**ABRACON, LLC
ENGINEERING/PROCESS CHANGE NOTIFICATION FORM**

ASVTX-11/ASTX-11 Series
SMD VC/TCXO

ECO# 3275

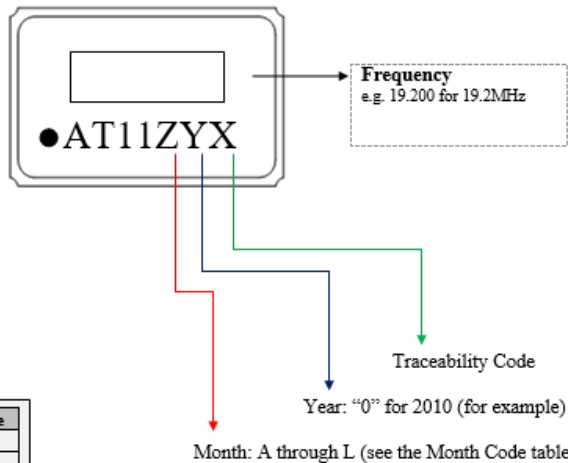
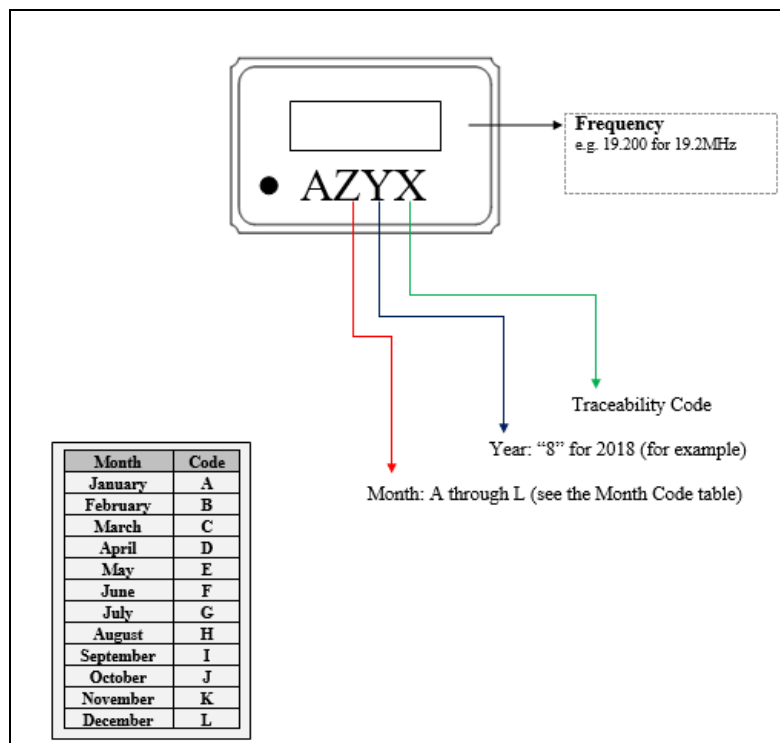
Revised laser marking scheme to updated format.

Previous Marking Scheme (Rev. M):

Line 1= Frequency

Line 2= 8 characters:

- Pin 1 indicator dot, "A", "T", "1", "1", "Z"
 (month), "Y" (year), "T" (traceability)

Updated Marking Scheme (Rev. N):

Line 1= Frequency
(same as previous marking)

Line 2= 5 characters:

(number of characters decreased from 8 to 5)

- Pin 1 indicator dot, "A", "Z" (month), "Y" (year), "T" (traceability)
